ALIGNMENT AND CROSS SECTIONS:

10TH ST - 1ST ST

P. 1

Q- How do the four
11' lanes fit
between the exist.
structural supports
on the RR underpass?
The pages "Project Plans"
(segment 1a → 2c),
← to the west have some
serious problems. They
are not covered here
because... the issues identified here are greater.
SEGMENT 3A

Section A

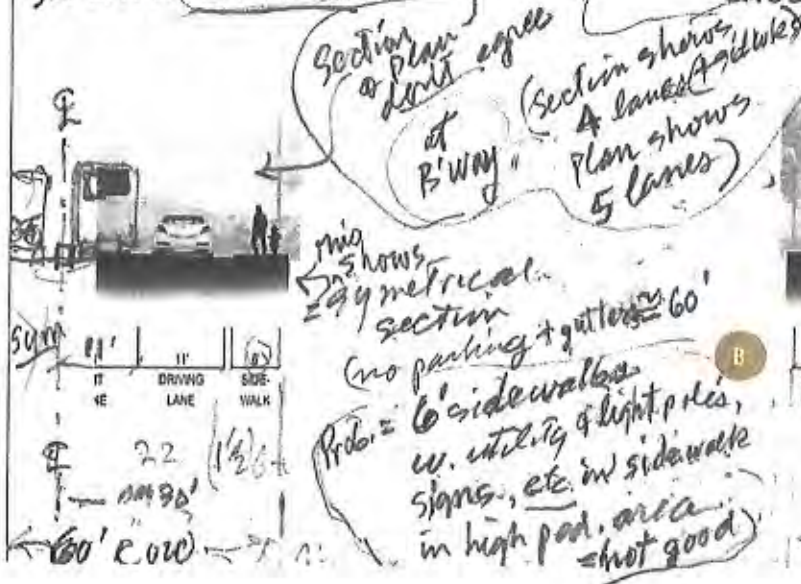
① Q. why? does cross section show
Two A.R.T. lanes (one E, one W)
on Copper & Gold?

② R.O.W. expansion for
ART stations not shown

OAK ST - BUENA VISTA D p.3

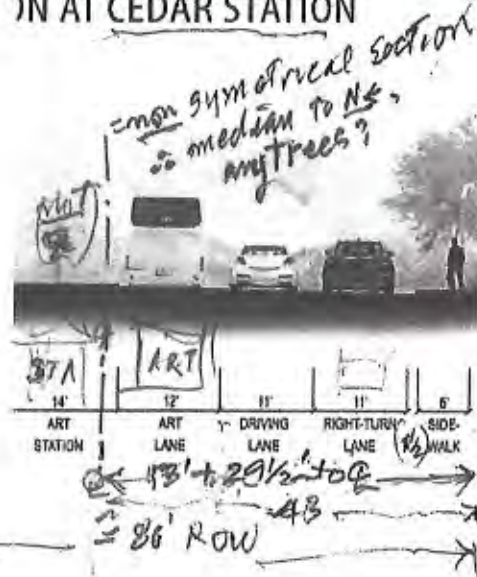
ON AT CEDAR STATION

CROSS SECTION *btw. Sycamore & Maple*

Q How is there room for landsc. @ Spruce St? Is R.O.W. expanded on N. side? (or S. side?).

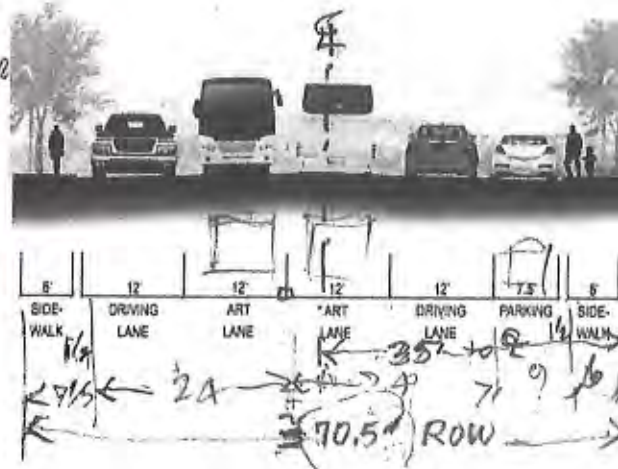
Plan appears to take ROW & re side walk remaining?

(isn't this a 60' ROW section?)
This is "Tight Grove"
(planted in 1890s)
I doubt if you will be able to take ROW from this.

LOUISIANA BLVD - UTAH p.8

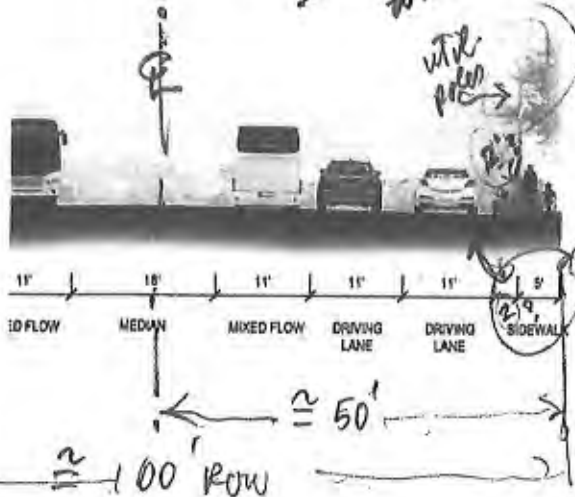
Symmetrical signal but don't need 18' medians with only 5' wide side walks! (w/ utility poles, & signs etc blocking the roadway)

also 5' sidewalk with no protection from cars/trucks on 11' lane passing @ +/- 40 mph. (N.G.)

Q. 2 does this mean = cut-off (median) = no access to all streets between "Traffic signal for left turns & u-turns"? Unless there is a barrier on the median between the ART lanes, (e.g., this appears to be > 2500 btw. Louisiana & Pennsylvania!) (and) No one would walk that far to cross the street, or to drive down to a signal to get to a store on the other side!

CECMENT **6A**

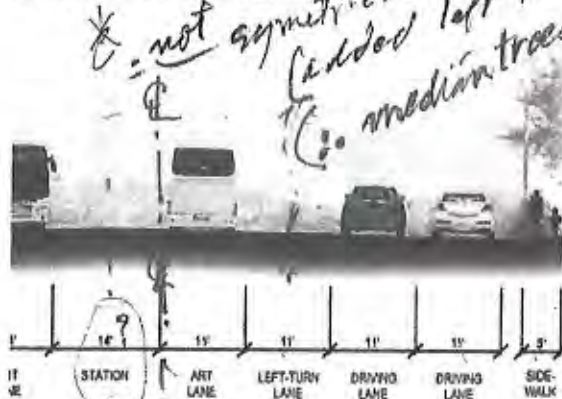
Q: What happens @ the intersection w. Zuni?
(existing signalized intersection)
18' median w. 5' sidewalk
and no parking? makes this a 'forbidding' area for pedestrians
= Symmetrical, but

CROSS SECTION B

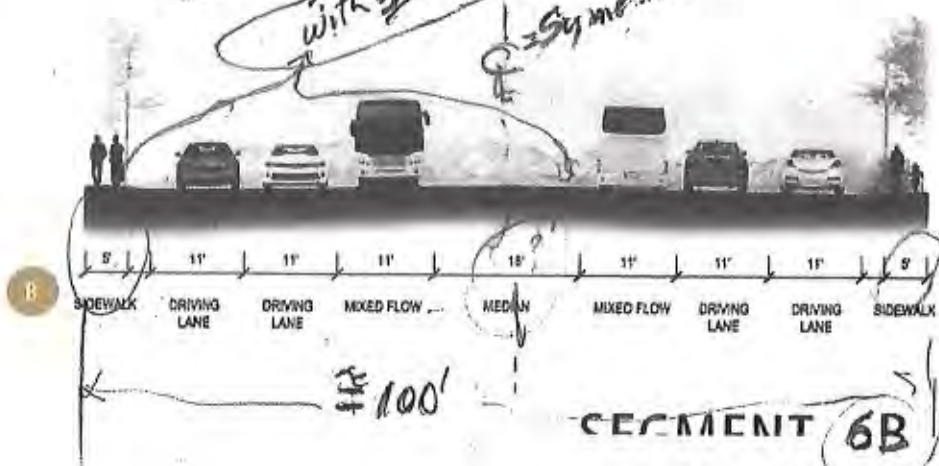
ran out of other side

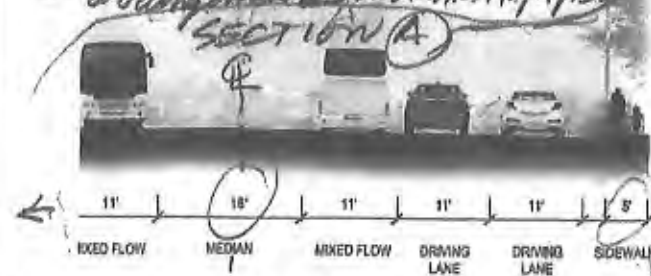
Two drawings w. title "Conceptual Plan", called "Landscape Buffer in median" and "at sidewalk". Unfortunately, these "Conceptual Plan" images do not appear anywhere (that we can find) in the "Project Plans" drawings.

Also, the Section "Landscape Buffer at sidewalk section" (Travel Lane + parking + Landsc.) appears to differ from the "Project Plan" drawing (AC).

This (Ped. crossing & street furniture "bump-out") is a much better configuration. It is NOT a "bulb-out" as shown on other "Project Plan" drawings.

★ Length of tangent for "bump-out" (min) = 2x width of tangent. (1) This before segment 7A

★ Please see a recommended bump-out (or flare-out) design on new page 7B attached here → at end (last page).

DWG "78"

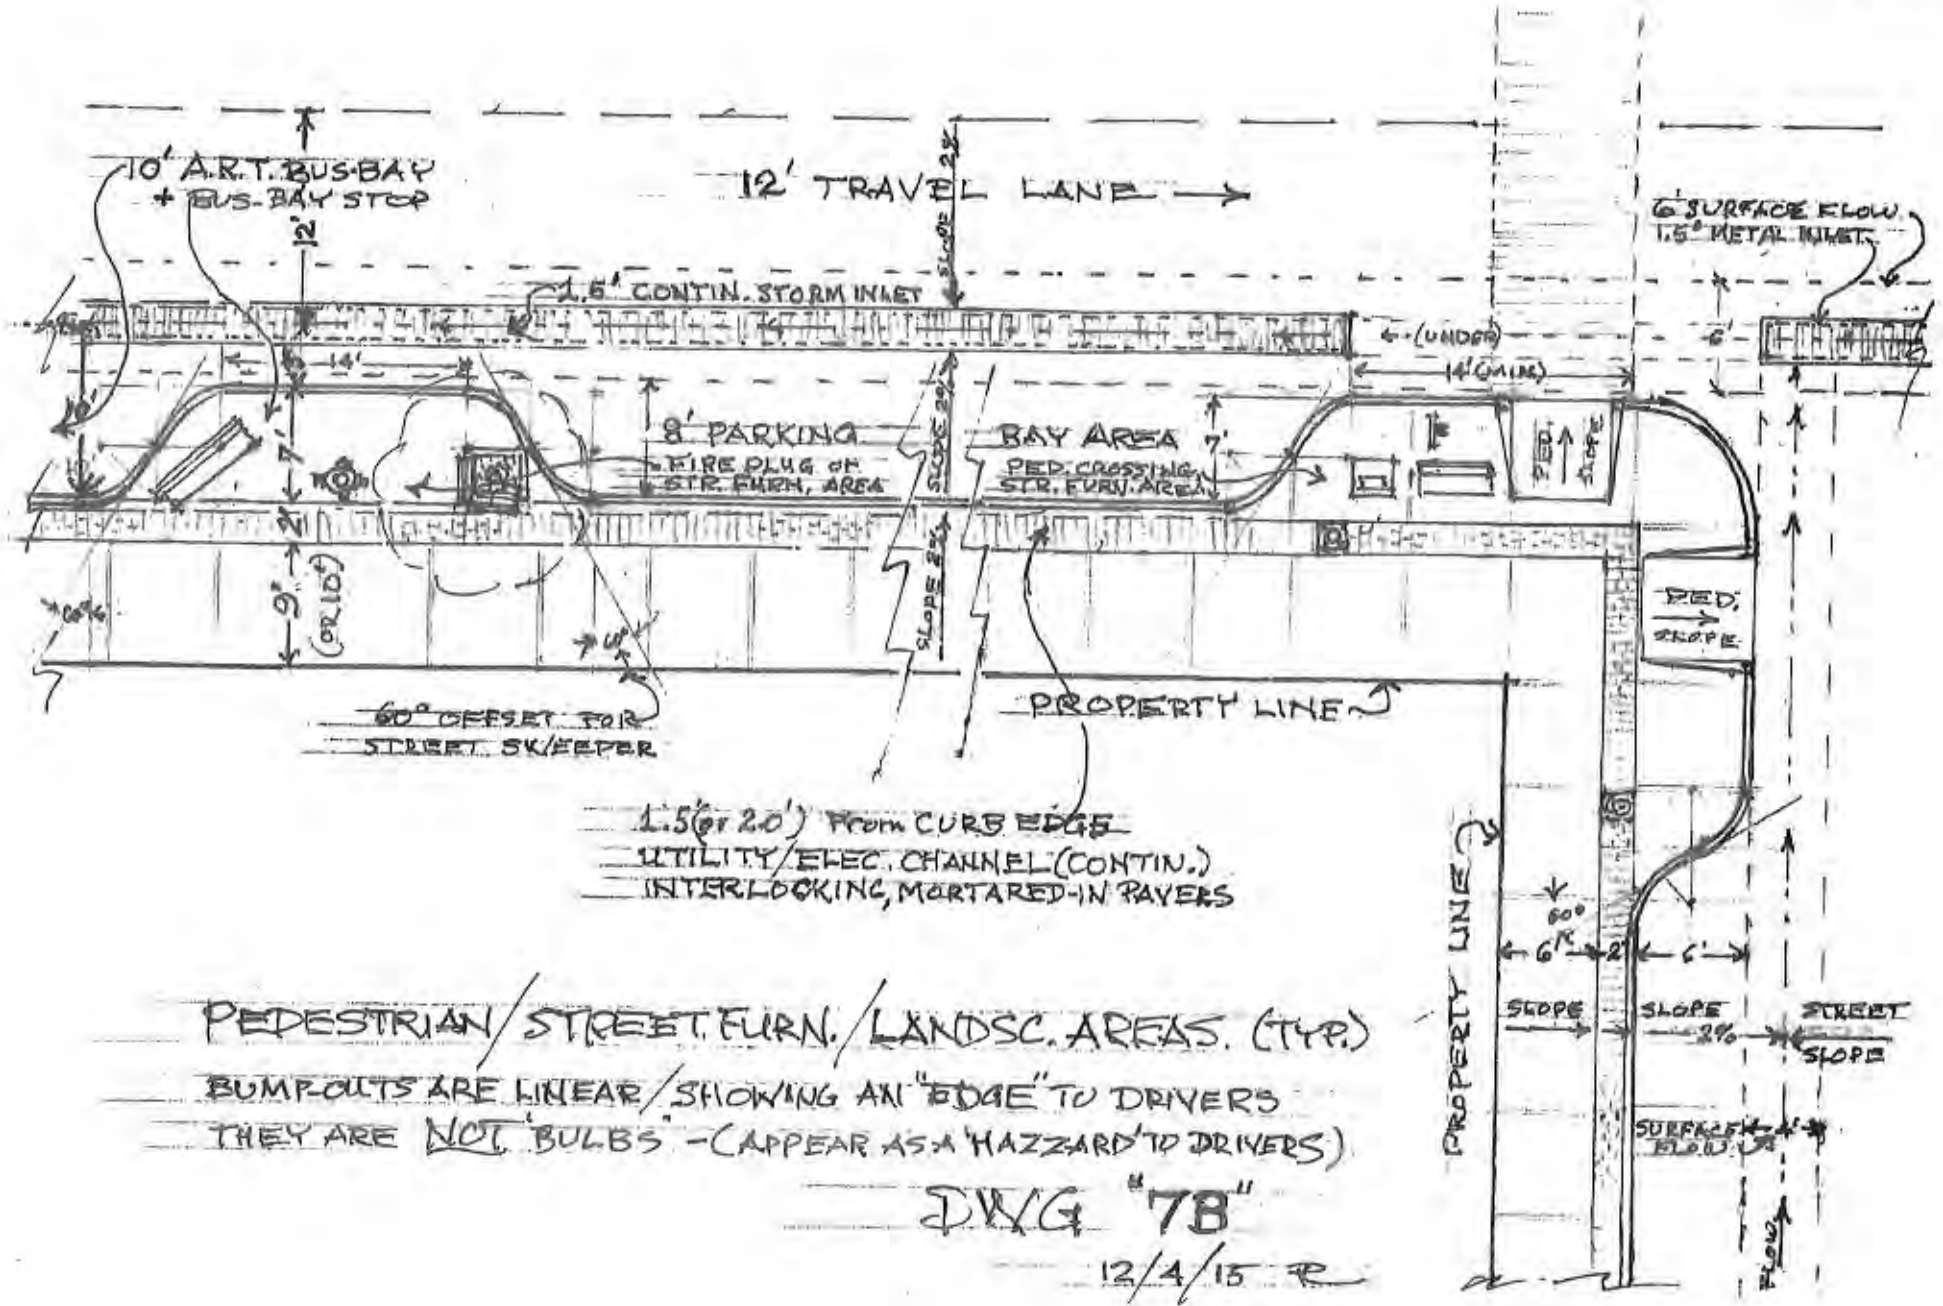
PEDESTRIAN/STREET FURN./LANDSC. AREAS. (TYP.)

BUMPOUTS ARE LINEAR/SHOWING AN "EDGE" TO DRIVERS

THEY ARE NOT 'BULBS' - (APPEAR AS A 'HAZZARD' TO DRIVERS)
